City of Tacoma

**ADDENDUM NO. 2**

**REVISIONS TO:**  
**Request for Bids Specification No. PW23-0003F**  
**Streets Initiative Package #15**

SHEET NO: 20

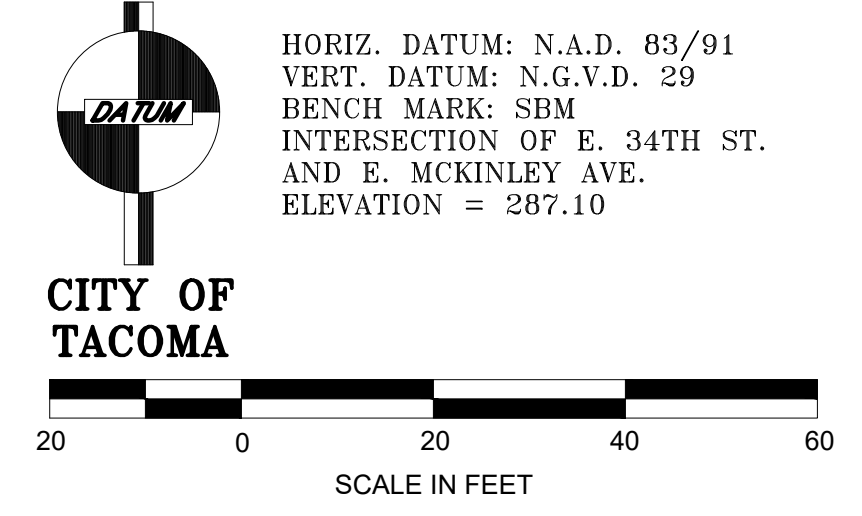
**Question 2: R-69, Remove and replace junction boxes, 5 each. I count 8. R-71, Street Light, there is no method of payment noted in the specials. There is no bid items for page 19, which has type 2 junction boxes, 2" conduit and 3" conduit. Nor do the specials note any method of payment.**

Answer 2: Discrepancies noted in the above comment submitted to the City have been addressed in Addendum 2 with specification plan and quantity revisions.
